**Bridge Factors Factual Report Attachment 22 – BPA Cracks Report No. 2 - Email from
Mr. Jose Morales of BPA to Mr. Rodrigo Isaza of MCM dated February 28, 2018**

Miami, FL

HWY18MH009

From: Jose Morales
Sent: Wednesday, February 28, 2018 3:32 PM
To: Rodrigo Isaza [REDACTED]
Cc: [REDACTED]; Ernie Hernandez [REDACTED]; Pedro Cortes; Rafael Urdaneta; [REDACTED]; Carlos Chapman; Maria Christina Acosta
Subject: Main Span 1 - Cracks Inspection on Truss Members after formwork / scaffolding removal
Attachments: CRACKS REPORT AFTER SHORING REMOVAL.pdf

CRACKS LOCATION

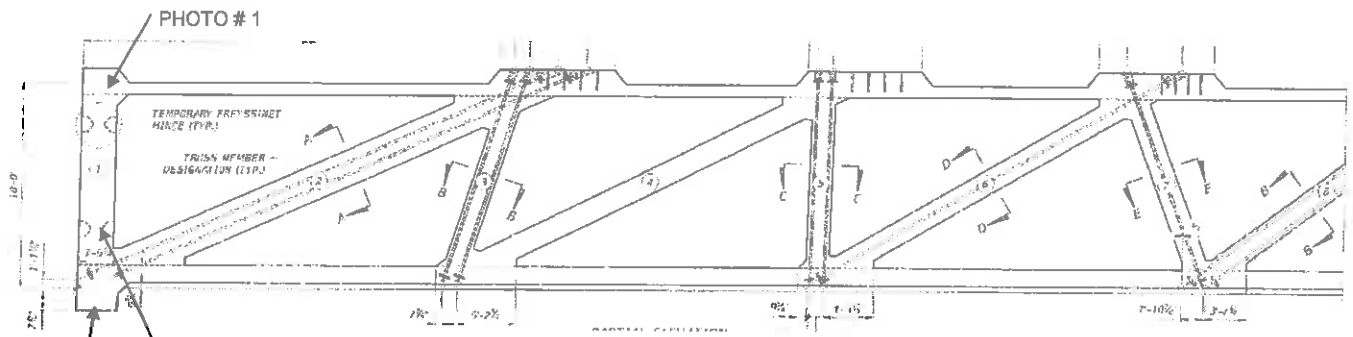
Please refer to the pictures attached regarding some cracks seen on truss members of Span 1 after the removal of the formwork.

Forward to the EOR for their information. We will monitor these or any other developing cracks on the bridge, but we would like to the EOR to provide a response and determine if these were expected during the bridge stressing. The one due the size that we believe needs special attention is the crack shown in photos 5,6 &7.

- CEI Report only contains three (3) pages of photos and one (1) page that shows the elevation view of Span 1 titled Cracks Location. The general locations of the cracks are depicted on this elevation view. Using the information provided by CEI, it is not clear from which side of the span the photos were taken since there is not a description of the location for each photo. Therefore, FIGG requests a more descriptive report of the crack locations and width.

- The cracks that are shown on photos 4, 5 and 6 appear to be in the reinforced concrete chamfer region of member 11. The elevation view locates these cracks on the downstation side of diaphragm number 2. It appears that the arrow that shows the general location of the crack was misplaced in the elevation view. These cracks developed at the boundary between the diagonal compression member and its reinforced concrete bottom chamfer. It is anticipated that MCM will seal these cracks in accordance with FDOT Standard Specifications.
